# E8361A-04A

# S E R V I C E N O T E

## E8361A PNA Microwave Network Analyzers

**Figure 2: A3 Front Panel Interface Board Assy with the Bracket Installed**

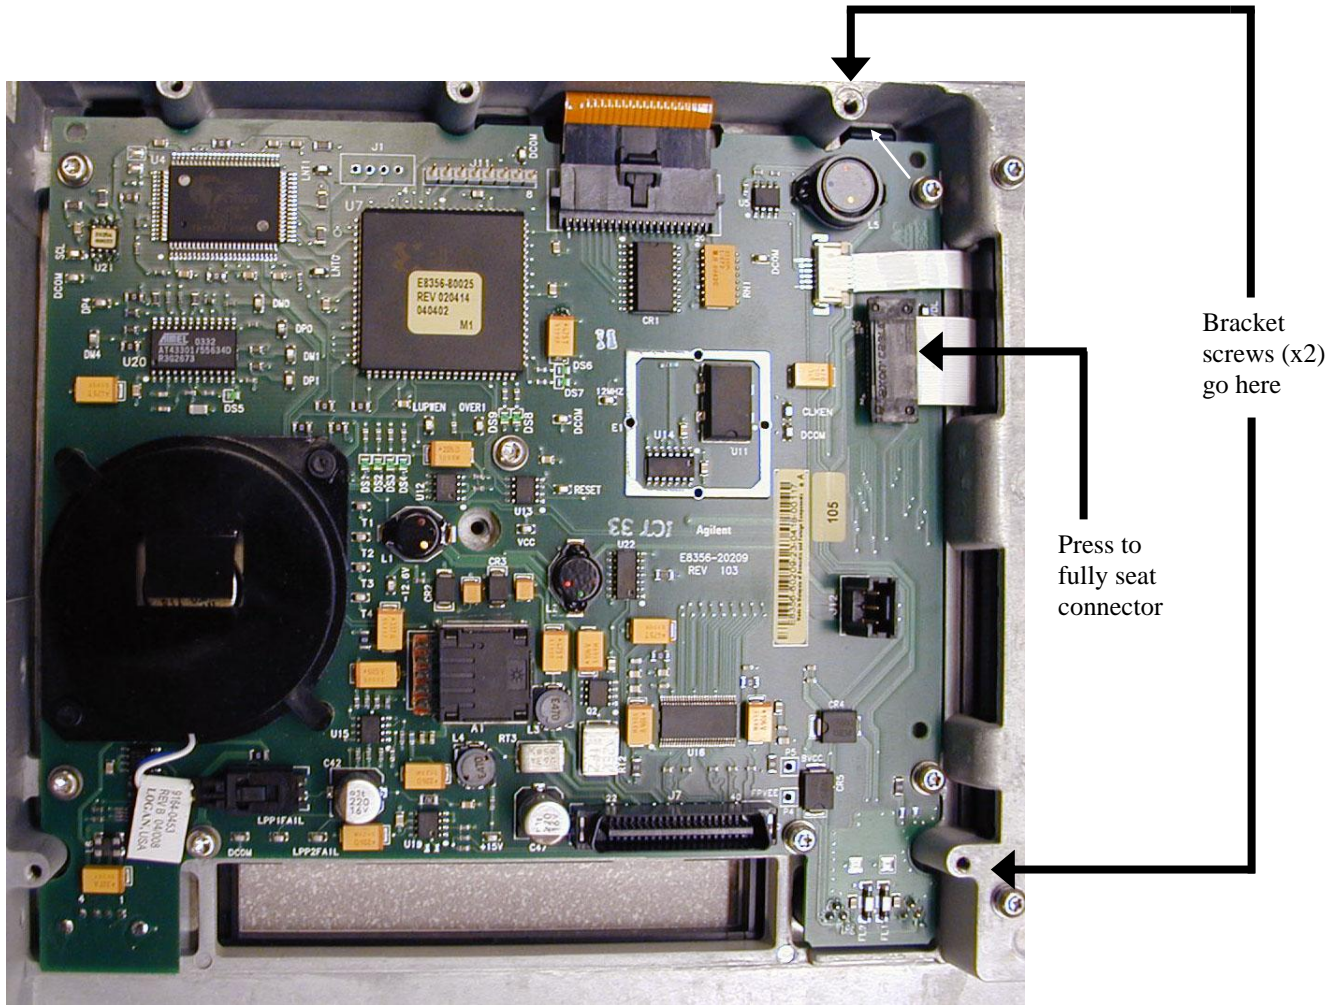
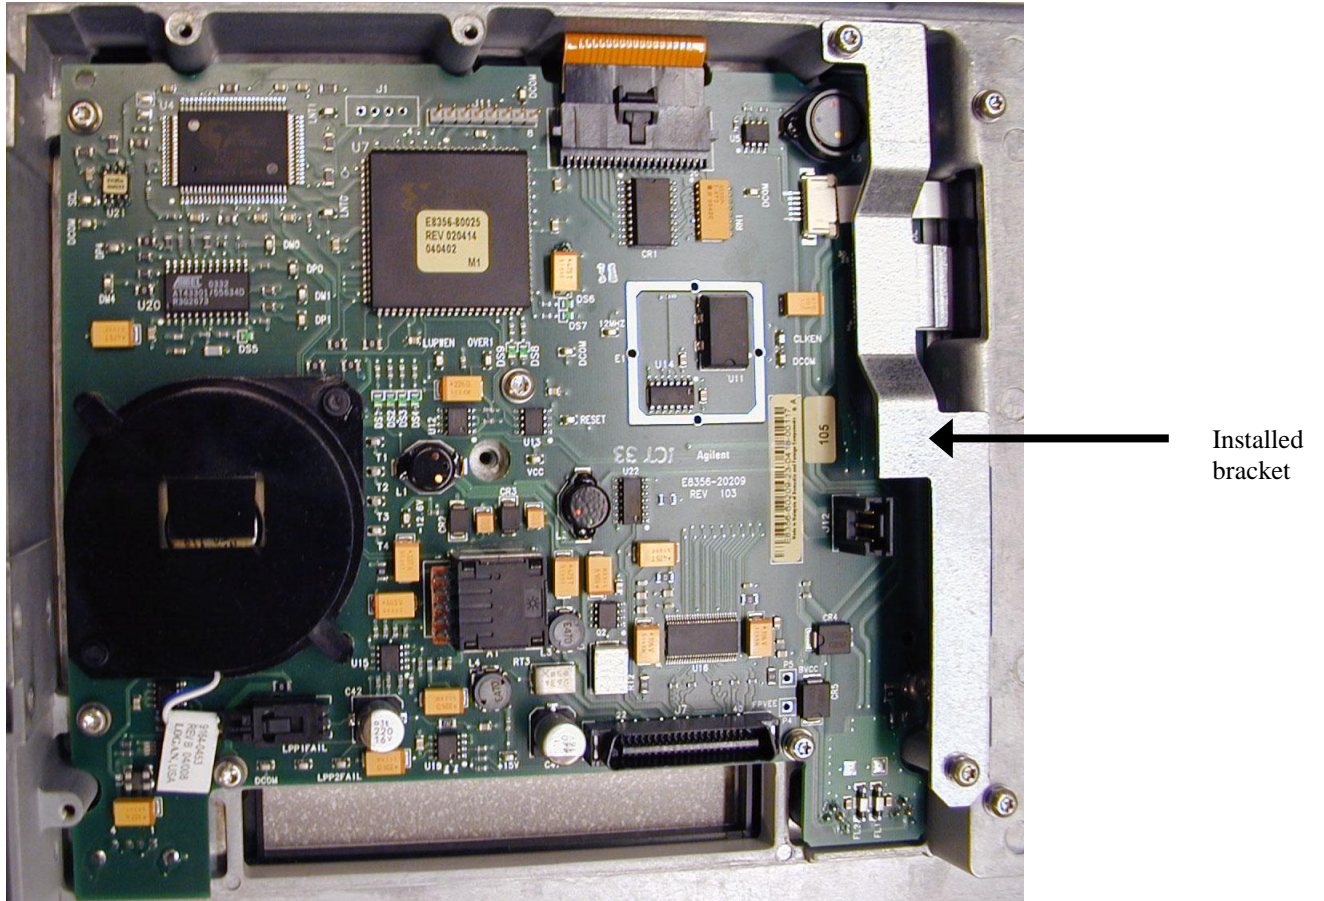
A connector of the ribbon cable (Agilent part number 8120-8409) that joins the front panel display to the front panel interface board can loosen, causing a display failure, unless a new bracket is installed. Because the failure rate has been very low, it is recommended that the bracket be installed only when there is an additional reason to remove the PNA front panel.

1. Refer to Figure 1 in this document:
  - Press down firmly on the ribbon cable's black connector.
  - Locate the two tapped holes for the bracket screws.
2. As shown in Figure 2 in this document, position the bracket so that its holes line-up with the two holes you located in the previous step.
3. Hand-start the two screws, and then torque both to 9 in-lbs.
4. Reinstall the PNA Front Panel by following the Service Guide instructions in the "Replacement Procedure." This is located on the same page as the "Removal Procedure" used previously in step 7.
